Product Change Notice (PCN)

Subject: Add Alternate Assembly Location for VFQFPN-80 Package

Revision 2

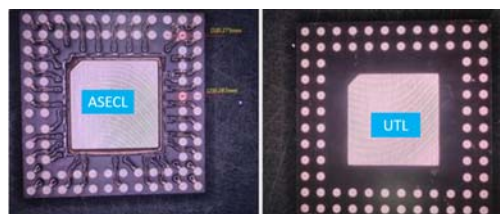
The change is expected will have no impact on the fit, function, quality, reliability and environmental compliance of the products. However, form will differ due to different insulation material. Copper traces are covered by solder resist but still visible in parts assembled by ASECL. Whereas for parts assembled by UTL, Copper traces are not visible since it is covered by the mold compound. Refer below images.
